ADDENDUM NO. 02

January 31, 2022

**Perry Township Academic Center
2115 E. Southport Road
Indianapolis, IN, 46227**

PREPARED BY SCHMIDT ASSOCIATES FOR:
PERRY ACADEMIC CENTER JWR RENOVATION AND IMPROVEMENTS
PERRY TOWNSHIP SCHOOLS

GENERAL ASSEMBLY, RUVG1200 - UP PIPING

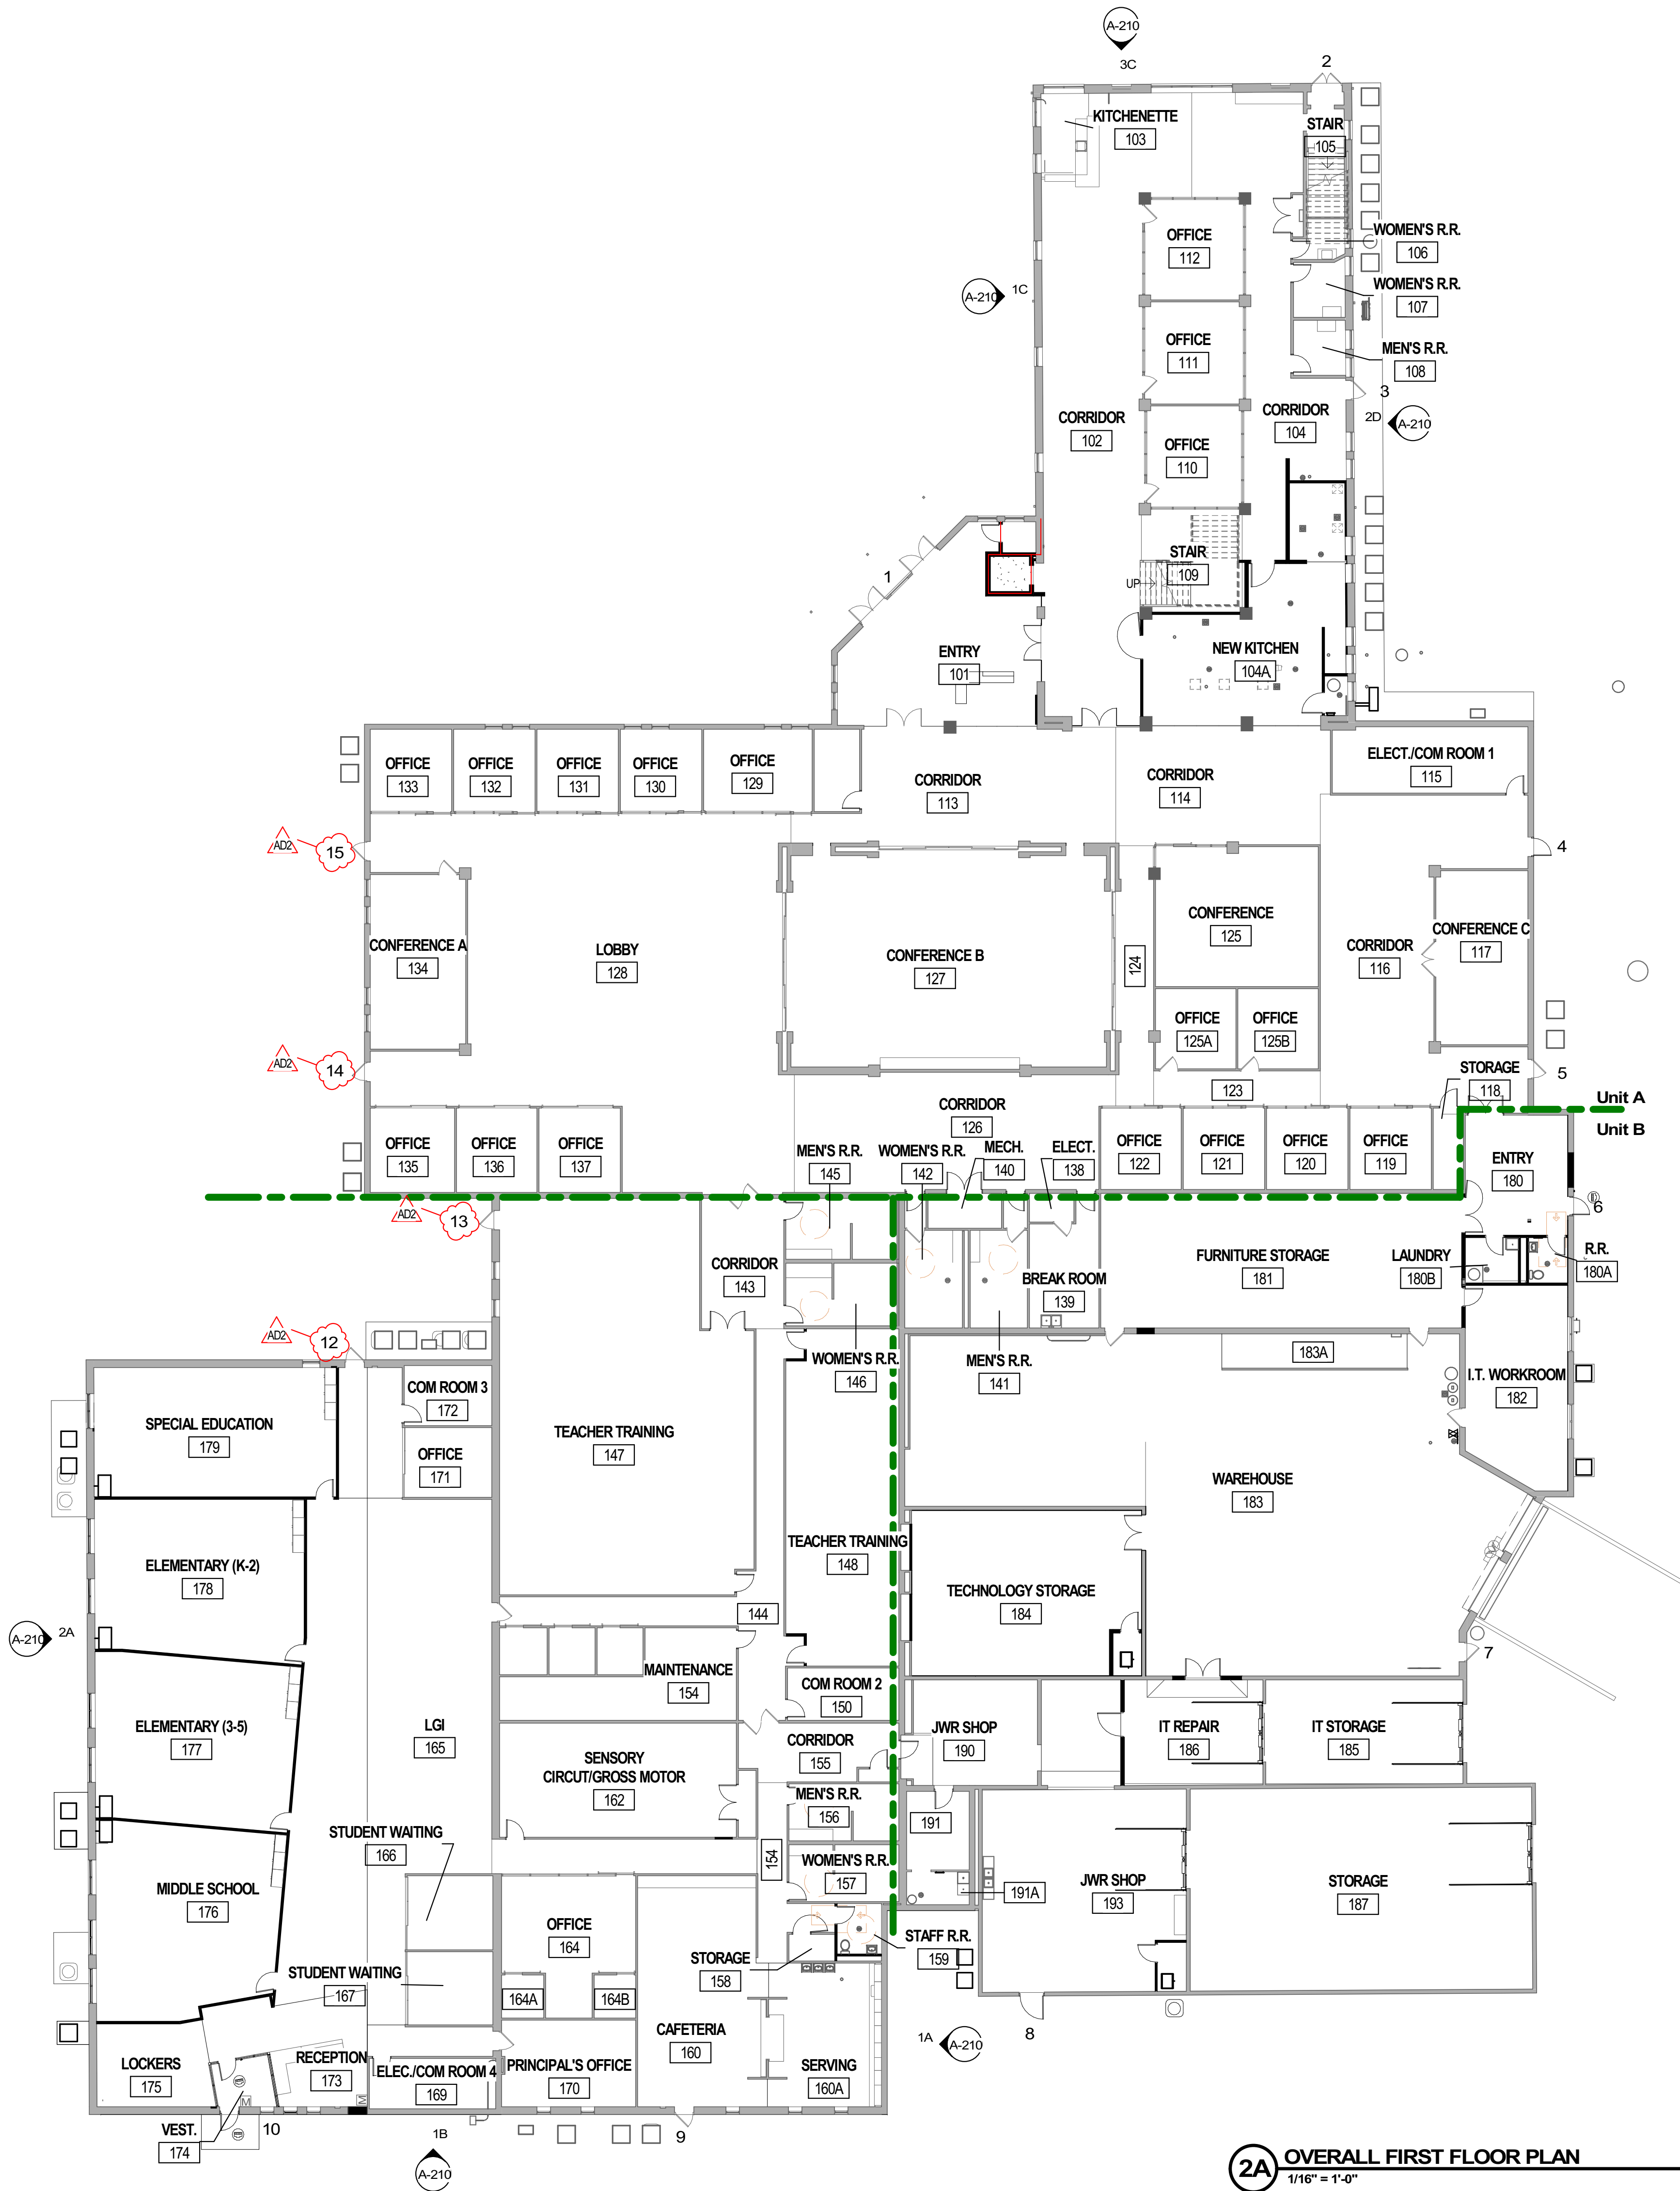
GAS VALVE ACCESS PANEL SHALL BE:
VUV-A, B, & C RIGHT SIDE. (FACING UNIT)
VUV-D - LEFT SIDE. (FACING UNIT)

PROVIDE 12" BASE SECTION TO ELEVATE THE DISCHARGE SECTION FOR GAS VENT THRU WALL.

ACCESS PANEL CAN BE LOCATED ON OPPOSITE SIDE. COORDINATION WITH ENGINEER PRIOR TO SUBMITTAL COMPLETION

2A OVERALL FIRST FLOOR PLAN
1/16" = 1'-0"

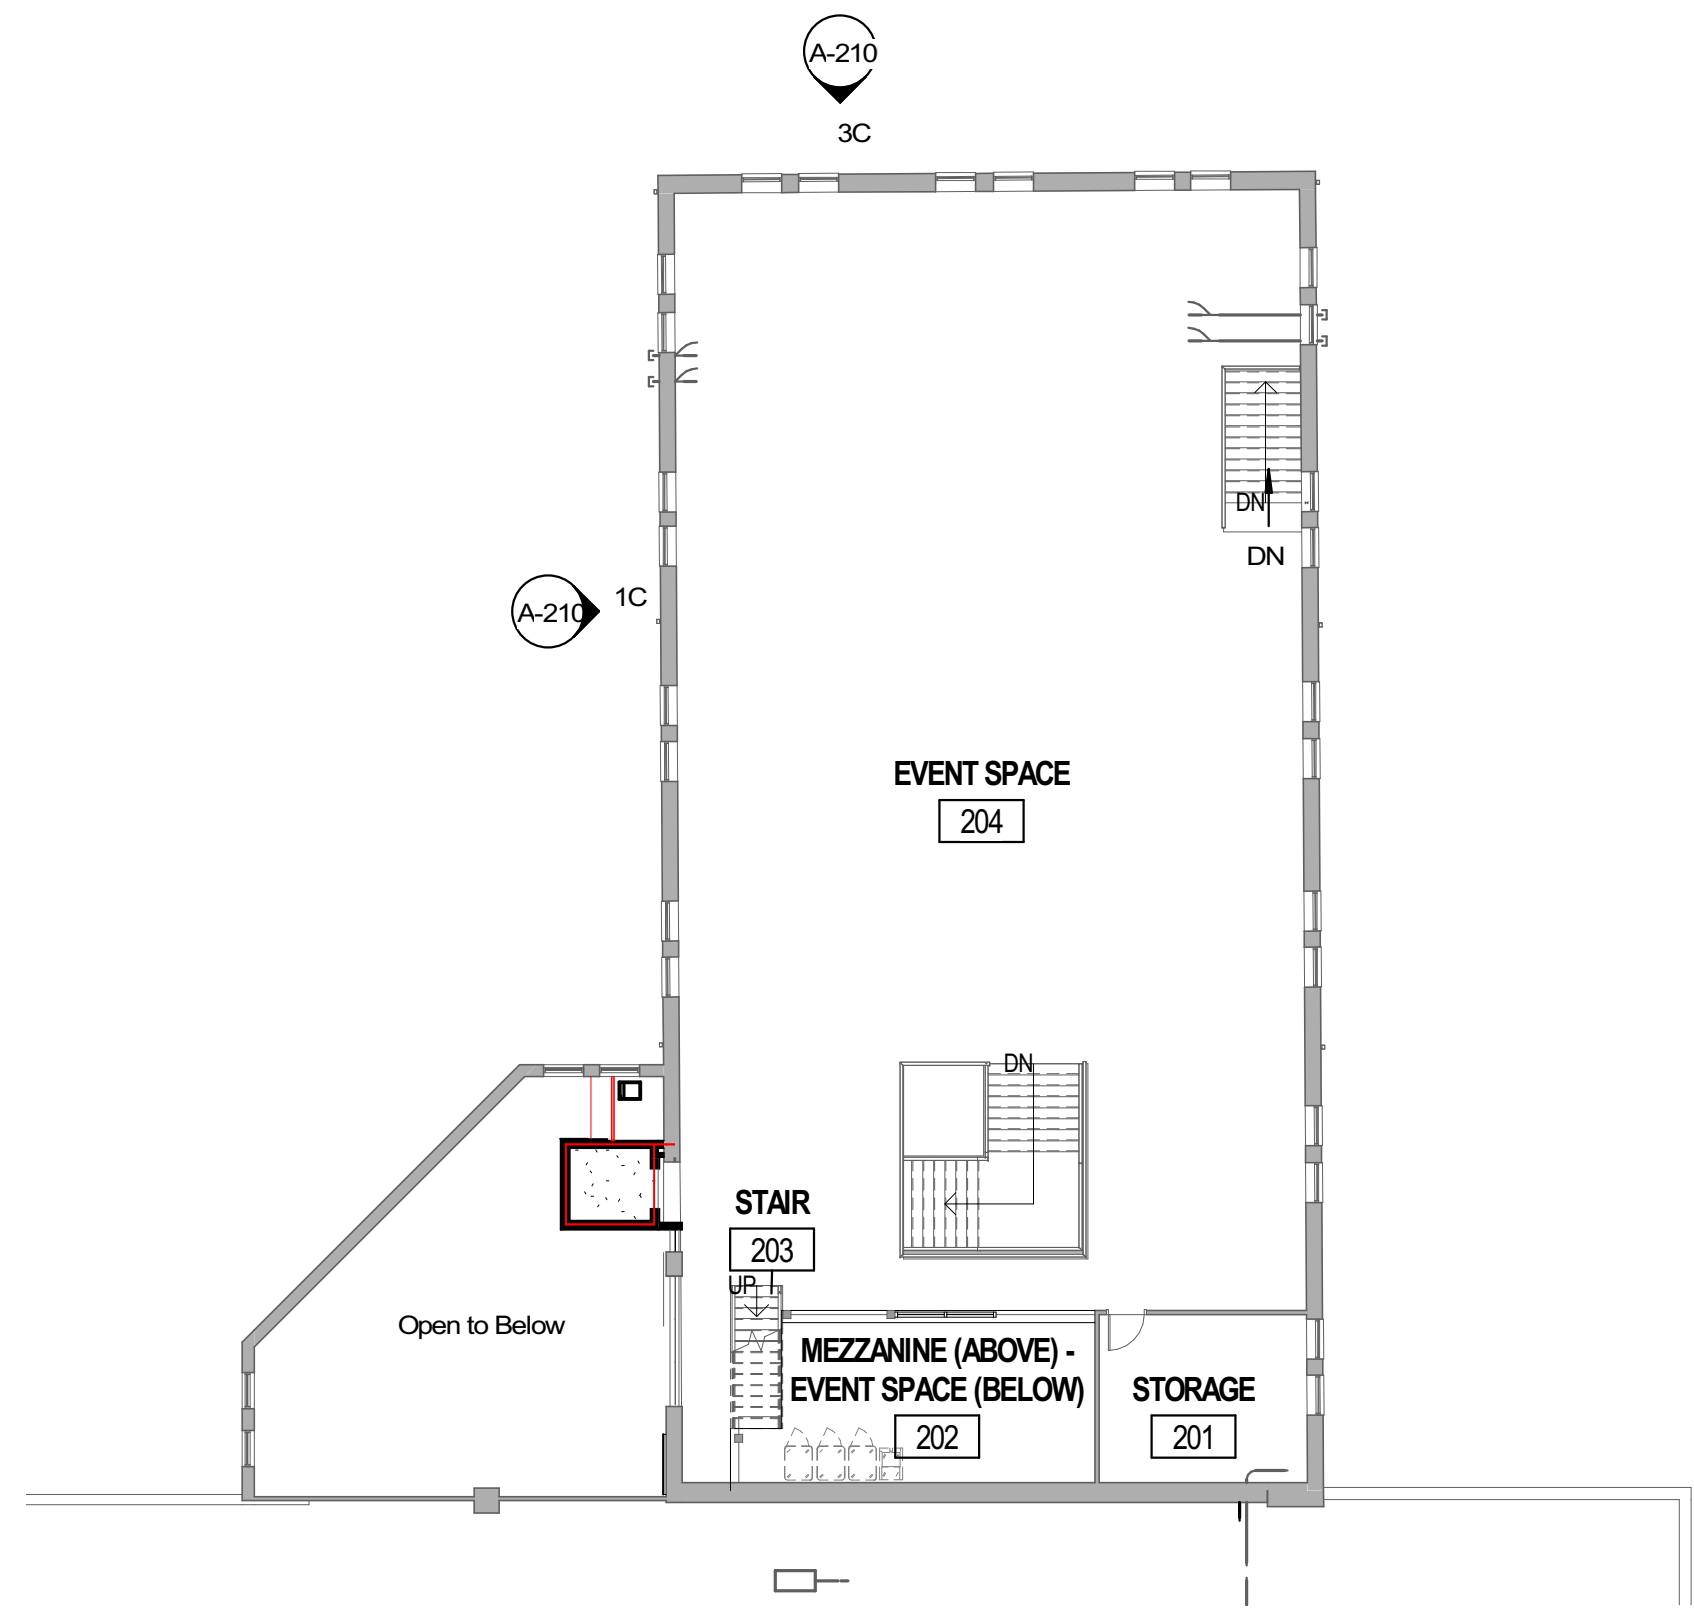
9. Q: Reference Plan Note 22 at the north entrance at Corridor 165A. This dimensional letter is not depicted on the Overall Floor Plan, sheet AF101. We interpret that this entrance is number "11". Note that there are three existing entrances at the west side of Units A and B that do not depict any entrance numbers. The overhead doors at Unit C have no entrance numbers. Please confirm that this is the designers intent.

A: See Addendum #2.
